ELK RIDGE ADDITION SEDGWICK COUNTY, KANSAS

RE: SUB 2003-148 -- Final Plat of Elk Ridge Addition

At the regular meeting of the Subdivision Committee of the Metropolitan Area Planning Commission on Thursday, April 29, 2004, the above captioned plat was considered. The action of the Committee was to approve the one-step final plat, subject to the following staff comments:

CASE NUMBER: SUB 2003-148 -- ELK RIDGE ADDITION

ELK RIDGE ADDITION

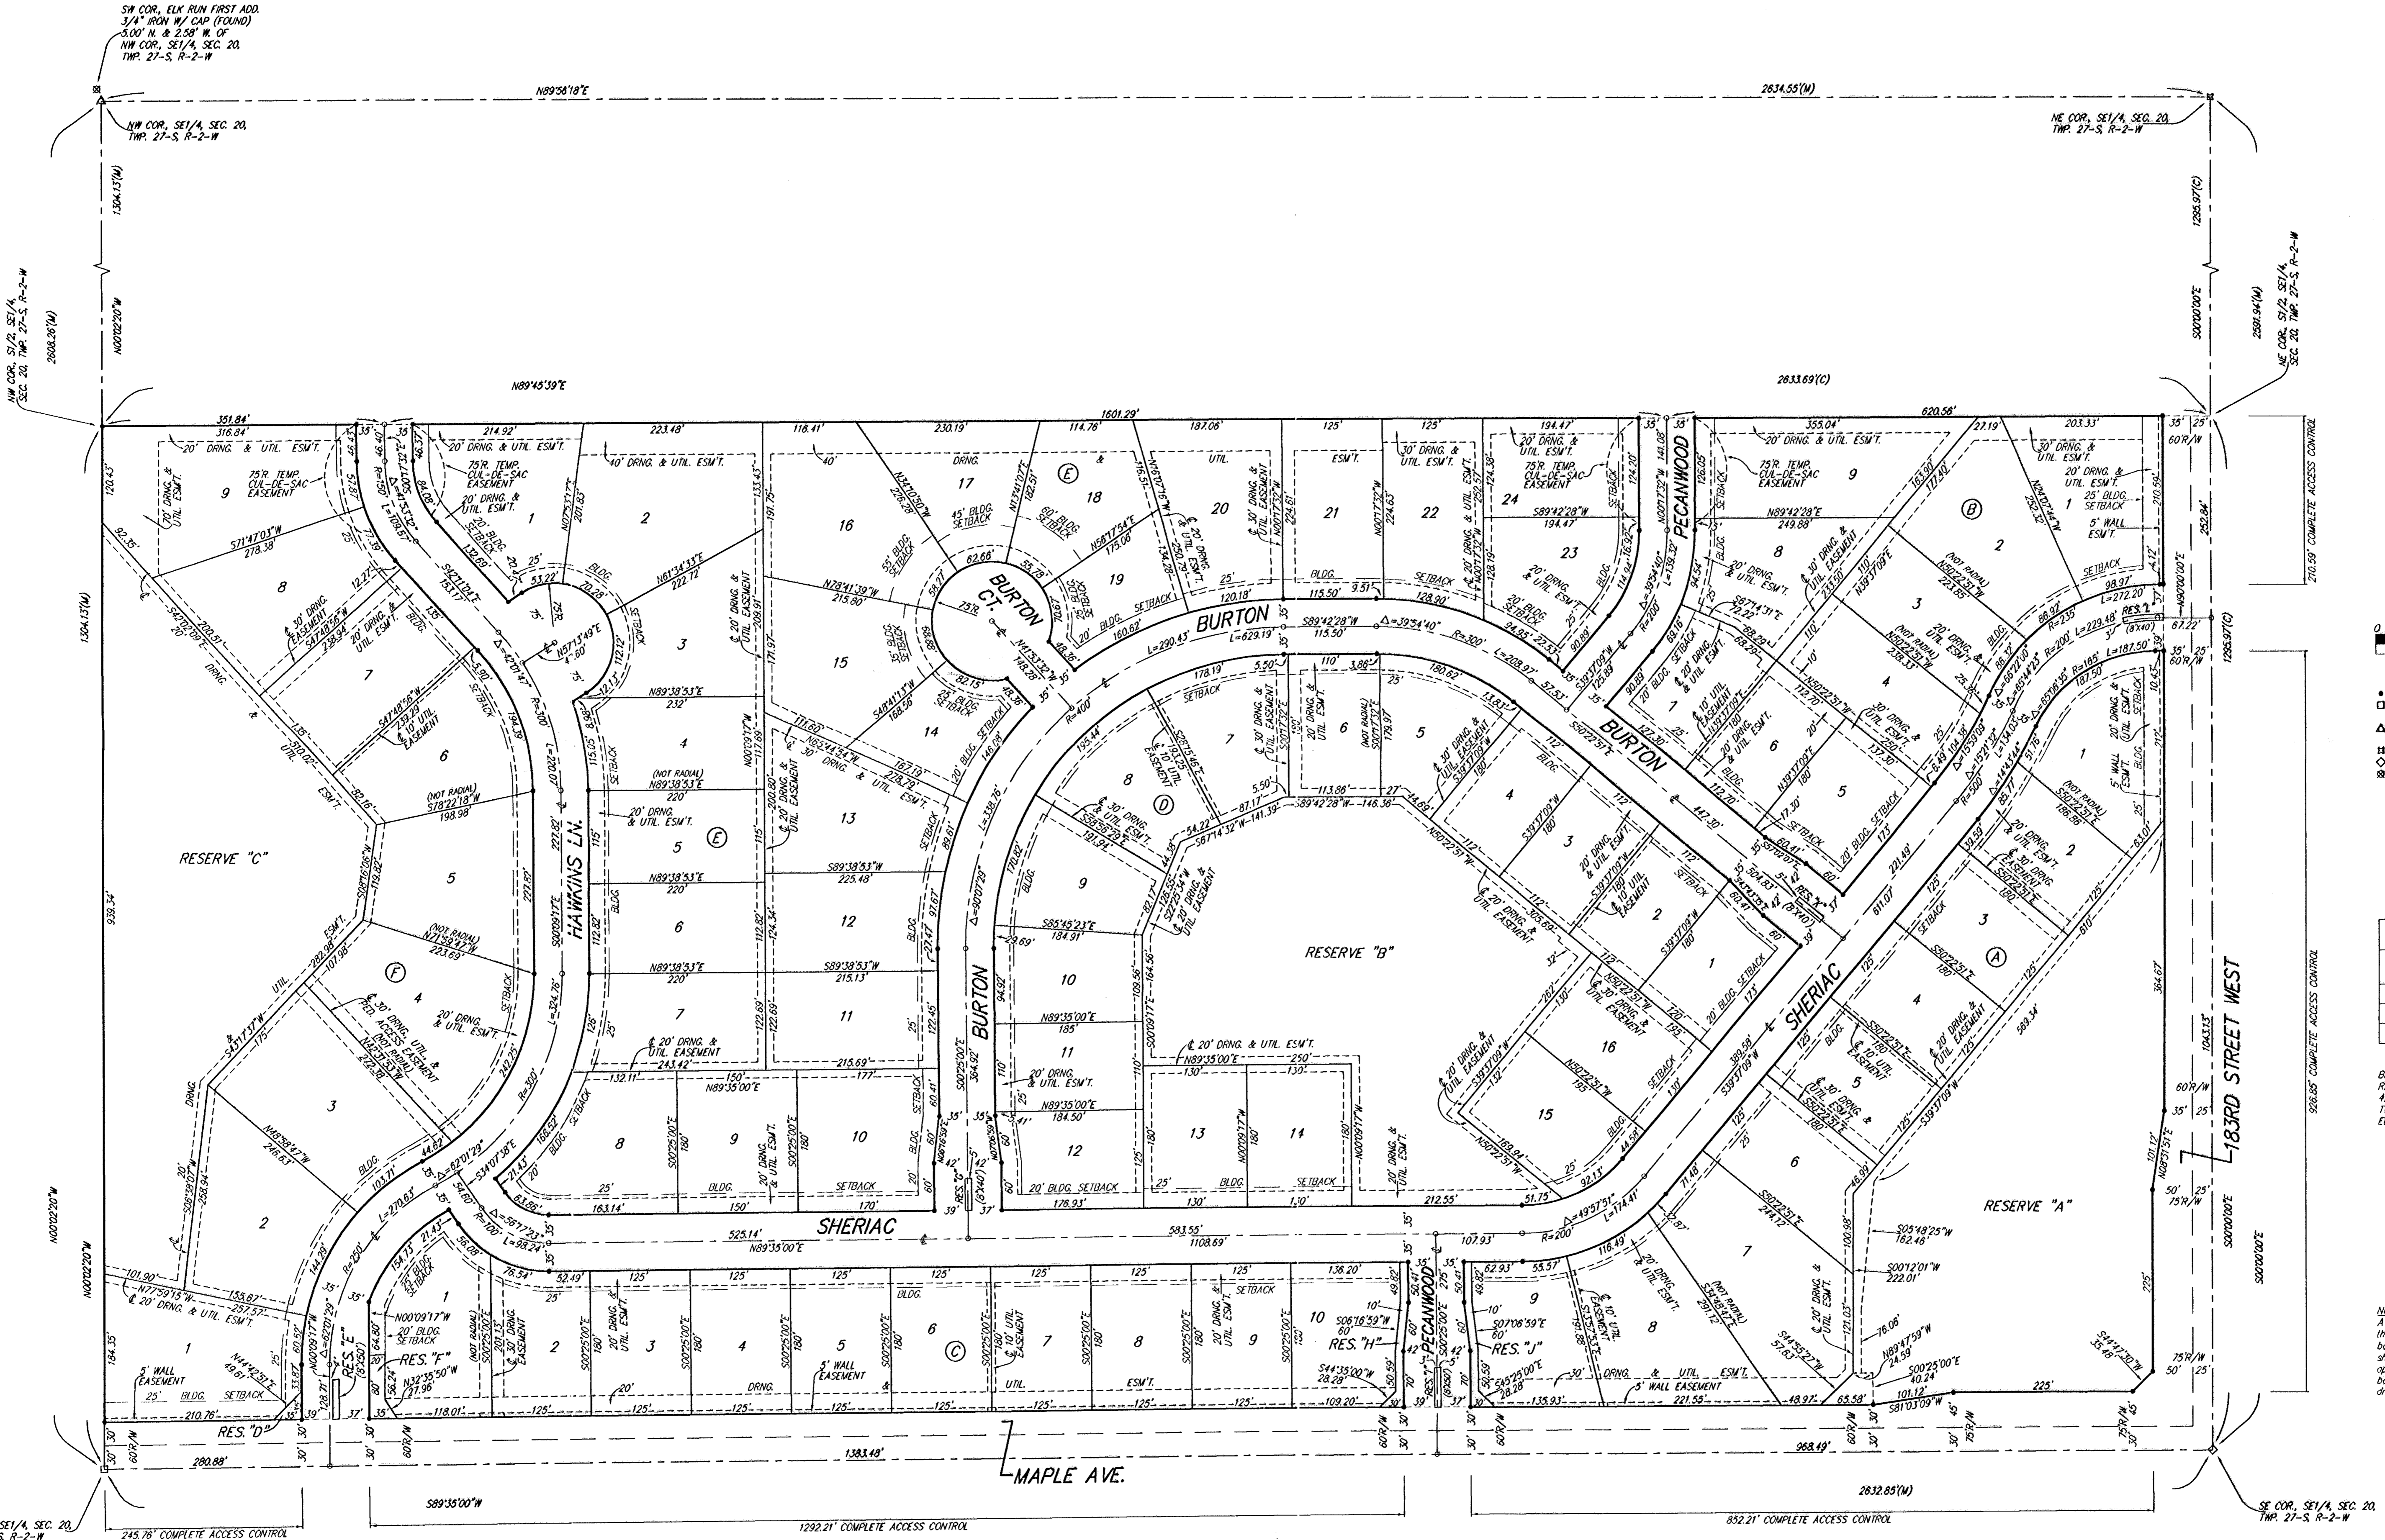
- D. County Engineering needs a drainage plan and a flood study, with minimum pads based on those results. Additional drainage easements may be needed based on the study. A Division of Water Resources permit may be needed.

- E. Since the subdivision is in a FEMA-regulated floodplain, the floodway certificate needs added.
- F. Access needs to be provided to Reserve A for maintenance from Sheriac.

- G. The temporary and permanent cul-de-sacs should have a 75-ft radius.
- H. The applicant shall guarantee the closure of any driveway openings located in areas of complete access control or that exceed the number of allowed openings.

- K. The street guarantee shall include the installation of a temporary turnaround at the terminus of Hawkins Lane and Autumn at the plat's north line. The plat's text should indicate that the vacation of the temporary turnarounds area will be effective upon the extension of the streets northward.

- L. It is recommended that Reserve C be extended to the street by access easements or by narrow strips of Reserve between the lots to increase its accessibility and usefulness for all homeowners in the Addition.

- Q. The plat's text shall include language that a drainage plan has been developed for the plat and that all drainage easements, rights-of-way, or reserves shall remain at established grades or as modified with the approval of the applicable City or County Engineer, and unobstructed to allow for the conveyance of stormwater.

A pedestrian access easement has been platted as requested.
- M. Provisions shall be made for ownership and maintenance of the proposed reserves. The applicant shall either form a lot owners' association prior to recording the plat or shall submit a covenant stating when the association will be formed, when the reserves will be deeded to the association and who is to own and maintain the reserves prior to the association taking over those responsibilities.
